<b>Subject:</b> <b>KNOCKING / SQUEAKING NOISE FROM FRONT SHOCK ABSORBER, CREAKING NOISE FROM FRONT LOWER ARM BUSHING</b>	<b>Bulletin No:</b> 02-010/16
	<b>Last Issued:</b> 03/10/2016

This bulletin supersedes the previously issued bulletin(s) listed below: The changes are noted in Red beside the change bars.

Previously issued TSBs:	Date issued:
02-003/15	12/17/2015 and 02/04/2015
02-005/13	08/24/2013 and 11/11/2013

### Improvement of Lower Arm Bushing

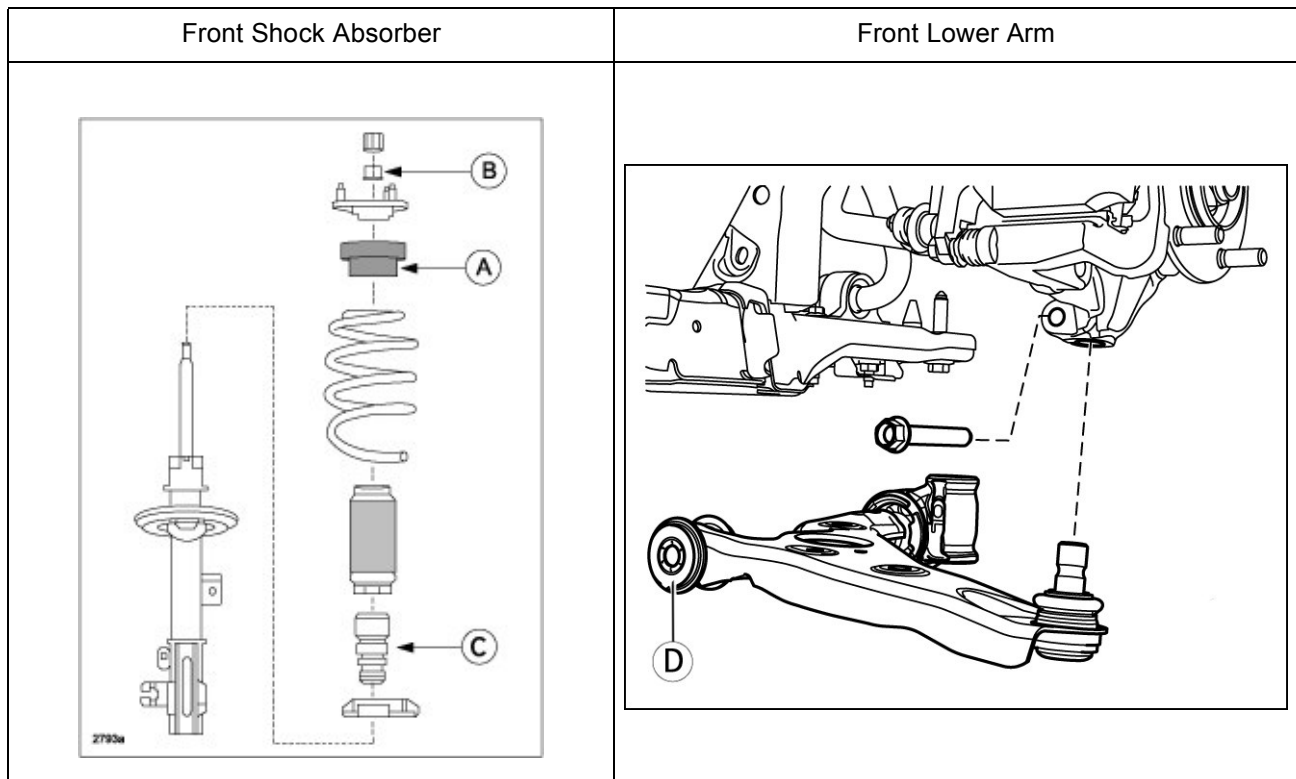
- upper front strut bearing (A) damage. (CX-5 and Mazda6)
- stick/slip between the front strut bearing and coil spring. (CX-3, CX-5 and Mazda6)
- the bump stopper (C) may be contacting the strut bearing when the front shock absorber is compressed, causing a popping noise. (Mazda6 only)
- **The front lower arm bushing (D) is making a stick-slip noise in wet road conditions.** (CX-5 and Mazda6)

1. The material and production method of the front strut bearing (A) has been changed. (CX-5 and Mazda6)
2. A protector has been installed onto the coil spring. (CX-5 and Mazda6)
3. The shape of the bump stopper (C) will be modified in the future. (Mazda6 only)
4. The shape of the coil spring has been changed. (CX-3 only)
5. **Friction of the lower arm bushing has been reduced by adding a dry coating.** (CX-5 and Mazda6)

Model	With VINs lower than	Produced before
2013-2016 CX-5	JM3KE*****742261	November 16, 2015
2014-2016 Mazda6	JM1GJ*****459655	November 16, 2015

### Install Protector onto Coil Spring (For Vehicle Type A, B and E)

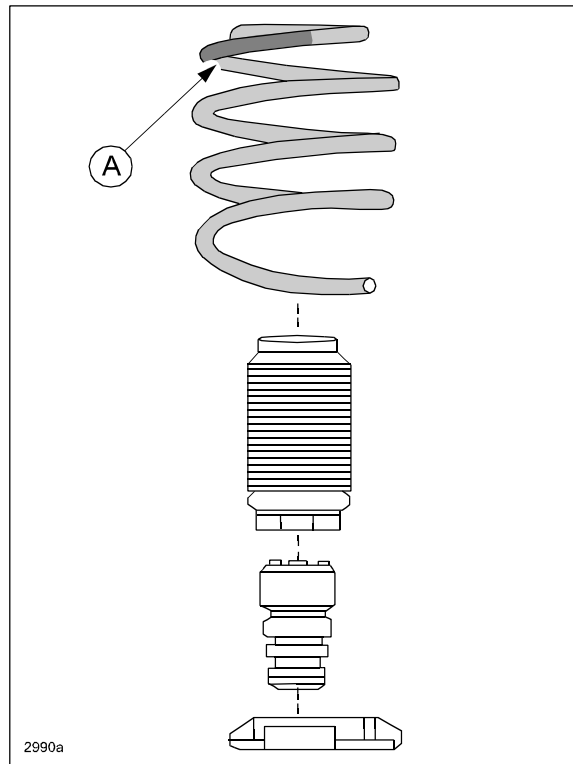
#### Coil Spring Protector (A) Installation:

3. Starting from the top of the coil spring, decrease the spring 1.5 coils downward.
4. Cut a thin strip of paper to 138 mm in length (or use a cloth type measuring tape).  
**NOTE:** For CX-3, use 130 mm in length.

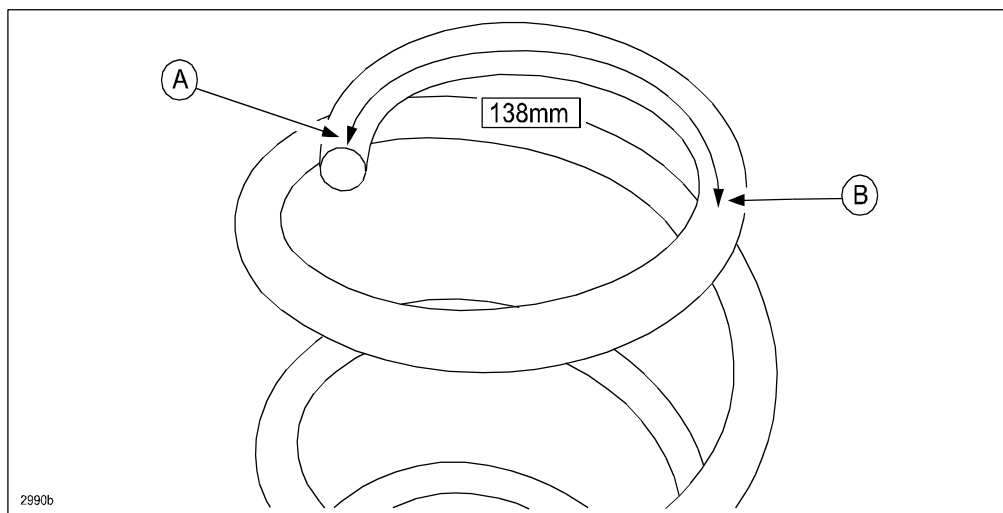
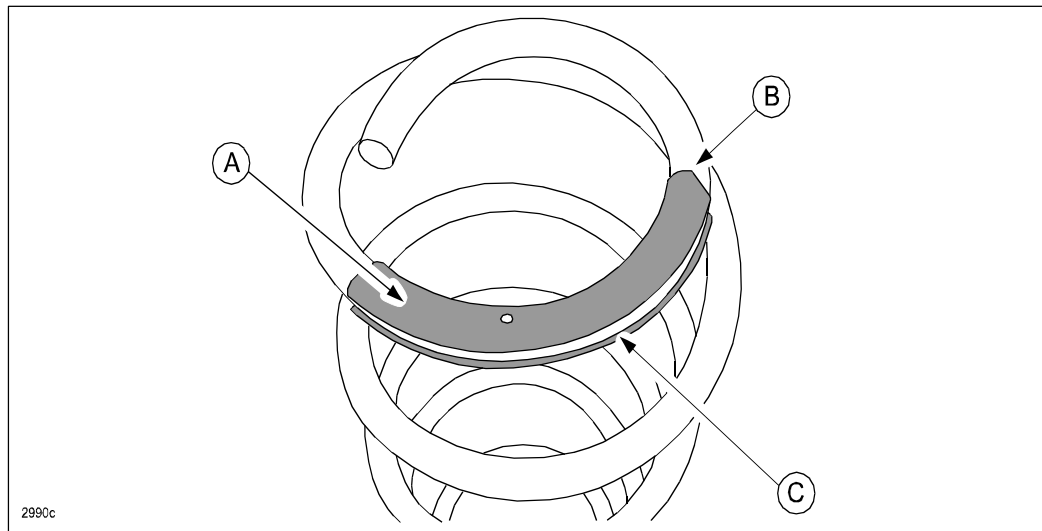
5. Place the strip of paper (or cloth measuring tape) along the inner side of the coil spring starting at point (A).
6. Mark the spot on the spring where (B) is. (B) is the starting point for the protector installation.

7. Install the protector (A) onto the coil spring aligning the end (slant cut side) with the marking at spot (B).

**NOTE:** Install the protector so the gap (C) is evenly aligned around the outer edge of the coil spring.

**Replace Bump Stopper (For all Mazda6 vehicles)**

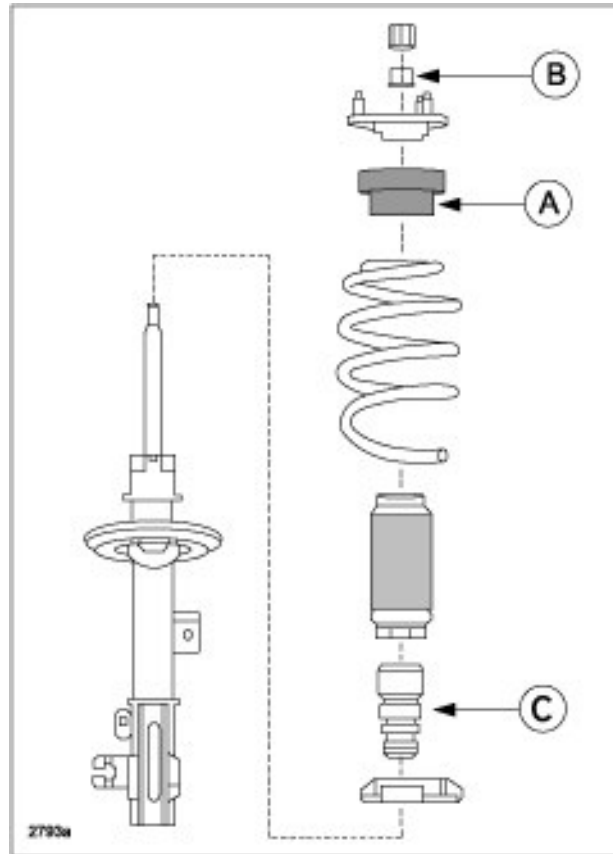
1. Remove the front strut bearing and coil spring according to MS3 online instructions or the Workshop Manual (section 02-13 FRONT SHOCK ABSORBER AND COIL SPRING DISASSEMBLY/ASSEMBLY).
2. Replace the bump stopper (C).

### Replace Lower Arm Bushing (For Vehicle Type A, B and C)

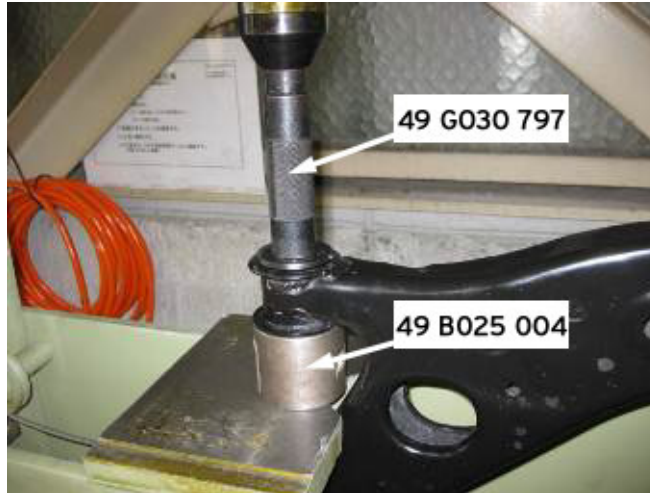
1. Remove the front lower arm (both sides) according to MS3 online instructions or the Workshop Manual (section 02-13 FRONT LOWER ARM REMOVAL/INSTALLATION).
2. Remove the front lower arm bushing using the SSTs.  
Set SSTs (49 G030 797 and 49 B025 004) and the front lower arm on a shop press as shown in the figure and remove the front lower arm bushing.

3. Install the front lower arm bushing (D) using SSTs.  
Install the front lower arm bushing so that the projection (A) shown in the figure is pointing toward the front (B) and out of the vehicle (C).

OK	NG
Tab is completely expanded	Tab is NOT completely expanded yet

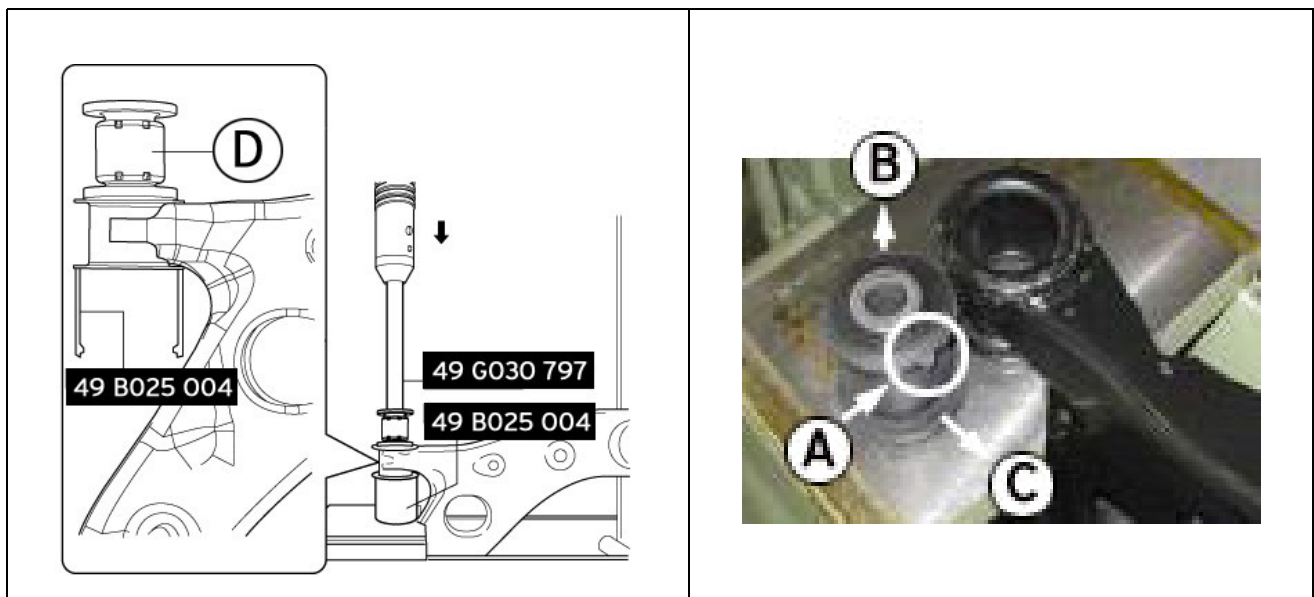
**CAUTION:** Make sure that the bushing has been properly inserted by checking that the tab of the bushing is completely expanded as shown in the OK illustration.

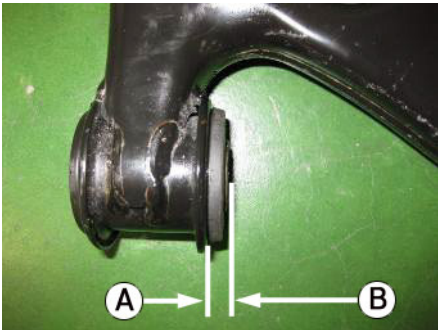
- After the installation, verify that the front lower arm bushing has been installed to the correct position by the procedure shown in the figure.

Measure the distance of the lower arm end face (A) and the inner pipe bushing (B).		Measure the width as shown

Specification: Width: 5.8 +/- 0.8mm (0.22 +/- 0.03 in)
